Item Name: Crosstube Turning Detail

DART AEROSPACE LTD	Work Order:	95445
Description: Crosstube Assembly (206B High Fwd)	Part Number:	D206-667-141
Inspection Dwg: D206-667-141 Rev: C		Page 1 of 2

DRAWING NO. D206-667-141	TITLE CROSSTUBE ASS'Y (206B HIGH FWD)	REV. C	DART AEROSPACE LTD ENGINEERING ORDER		D.E.O. NO. D206-667-141-C-1	SHEET NO. SHEET 1 OF 1	SCALE NTS
DRAWN <i>q</i>	CHECKED <i>ASS</i>	MFG. APPR. <i>JD</i>	APPROVED <i>MD</i>		DE APPR. <i>A</i>		
DATE 11.07.15	DATE 11.07.20	DATE 11.07.21	DATE 11/07/21		DATE 11.07.21

DRAWING NO. D206-667-141	TITLE CROSSTUBE ASS'Y (206B HIGH FWD)	REV. C	DART AEROSPACE LTD ENGINEERING ORDER		D.E.O. NO. D206-667-141-C-2	SHEET NO. SHEET 1 OF 1	SCALE NTS
DRAWN AJS	CHECKED J	MFG. APPR. E	APPROVED AP		DE APPR. H		
DATE 12.08.02	DATE 12.08.02	DATE 12.08.02	DATE 12.08.02		DATE 12.08.02

**D206-667-141
ASSEMBLY DETAIL
(VIEW LOOKING FWD)**

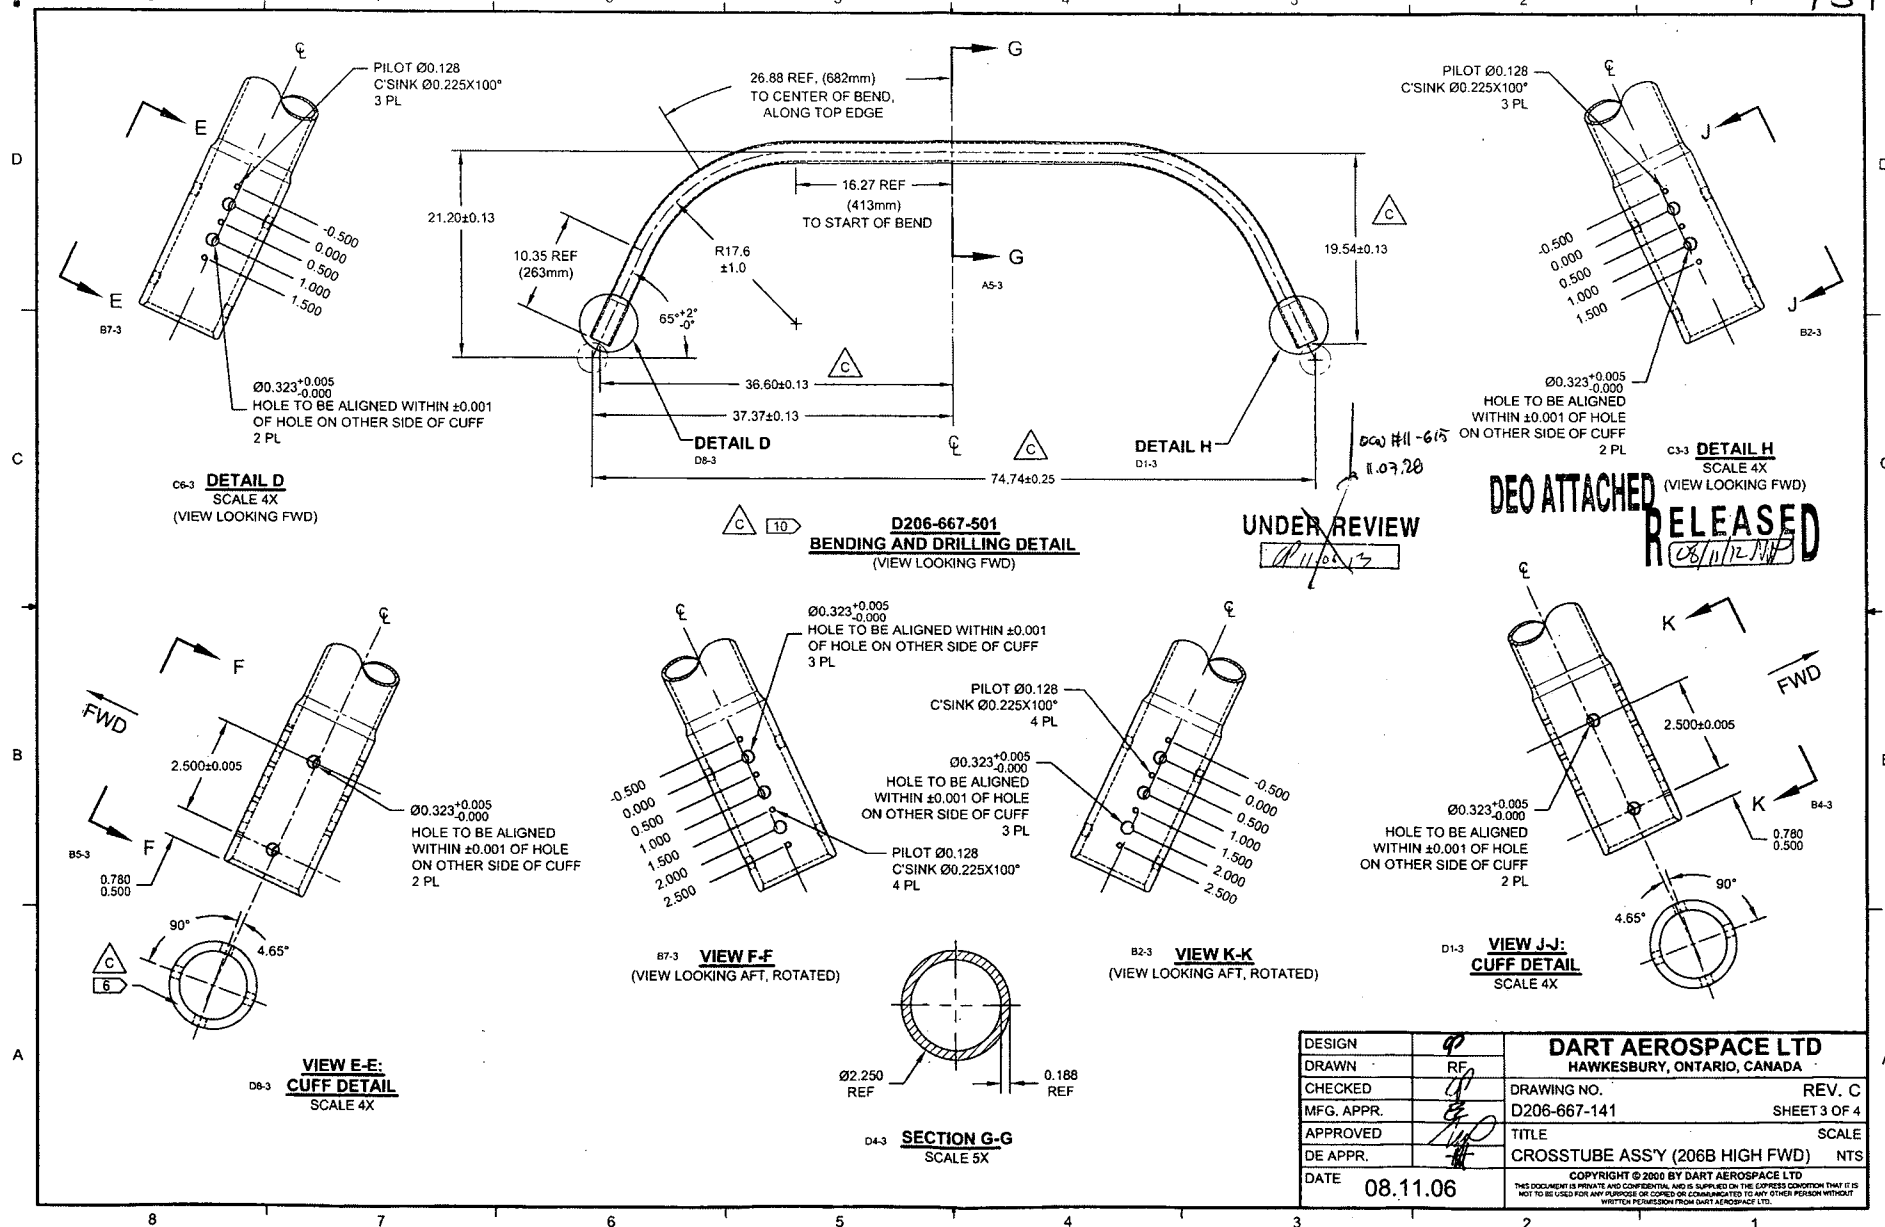
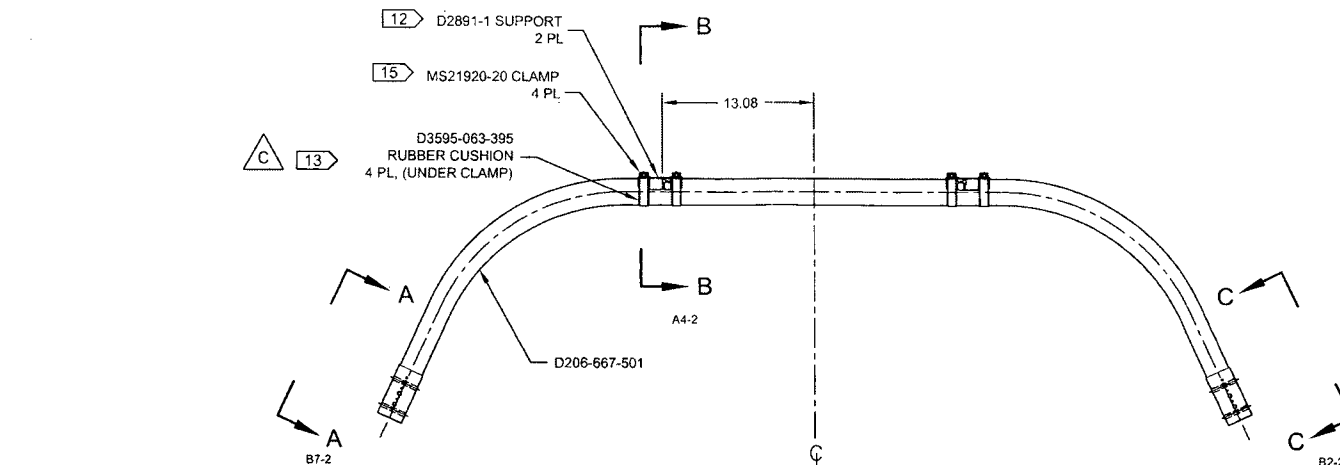
C	REVISE GENERAL NOTES/PART LIST (ZN D7-1); REORGANIZED VIEWS AND REFORMATTED DRAWING TO CURRENT STANDARDS. D3595-063-395 WAS D2856-400-694 (ZN D6-2 & A5-2); REMOVED REF. & ADD TOLERANCES (ZN C4-3, C5-3 & D3-3); RELOCATED FLAG #6 (ZN A8-3) PER NCR 210; MOVED TURNING DETAIL & UPDATED TOLERANCE TO SHEET 4.	RF	08.11.06
B	ADD HOLES AND NUT PLATES FOR COMPATABILITY WITH BHT/AA SKUDTUBES	PH	05.07.26
A	NEW ISSUE	CP	00.11.17
REV.	DESCRIPTION	BY	DATE
DESIGN	RF	DART AEROSPACE LTD HAWKESBURY, ONTARIO, CANADA	
DRAWN	RF		
CHECKED	RF	DRAWING NO.	REV. C
MFG. APPR.	RF	D206-667-141	SHEET 1 OF 4
APPROVED	RF	TITLE	SCALE
DE APPR.	RF	CROSSTUBE ASS'Y (206B HIGH FWD)	NTS
DATE	08.11.06	COPYRIGHT © 2006 BY DART AEROSPACE LTD THIS DOCUMENT IS PRIVATE AND CONFIDENTIAL AND IS SUPPLIED ON THE EXPRESS CONDITION THAT IT IS NOT TO BE USED FOR ANY PURPOSE OR COPIED OR REPRODUCED IN ANY MANNER WITHOUT WRITTEN PERMISSION FROM DART AEROSPACE LTD.

DETAIL P BONDING STRAP INSTALLATION 2 PL

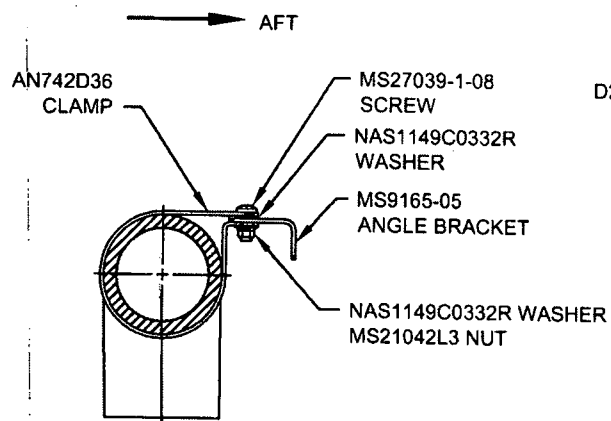
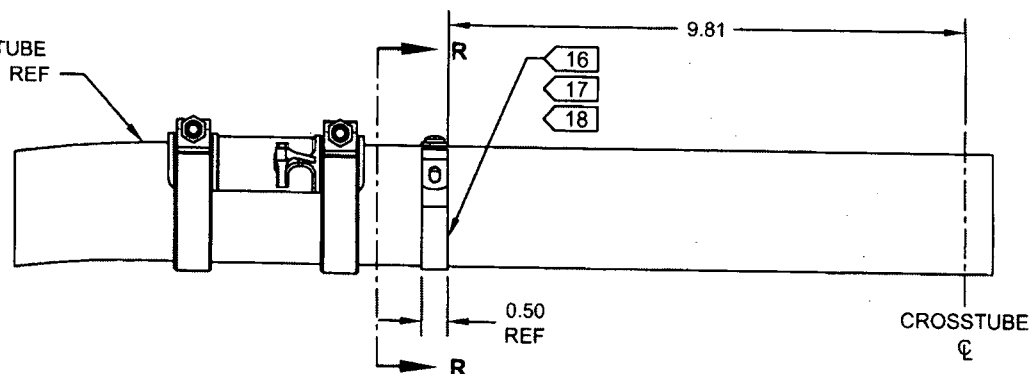
ADD ELECTRICAL GROUNDING STRAP

ITEM	QTY -141	PART NUMBER	DESCRIPTION
1	X	D206-667-141	CROSSTUBE ASSEMBLY (206B HIGH FWD)
10	2	AN742D36	CLAMP
11	2	MS9165-05	ANGLE BRACKET
12	2	MS21042L3	NUT (OR MS21042-3)
13	2	MS27039-1-08	SCREW
14	4	NAS1149C0332R	WASHER (OR AN960C10L)

- 16) MASK AREA UNDER CLAMP PRIOR TO PAINTING
- 17) SEAL EDGES WHERE AN742D36 CLAMP MEETS WITH THE CROSSTUBE USING SIKAFLEX-241/-291 OR MIL-S-8802 CLASS B2 OR PROSEAL 890 SEALANT
- 18) PERFORM RESISTANCE CHECK TO ENSURE MAX RESISTANCE IS 10 MILLIOHMS
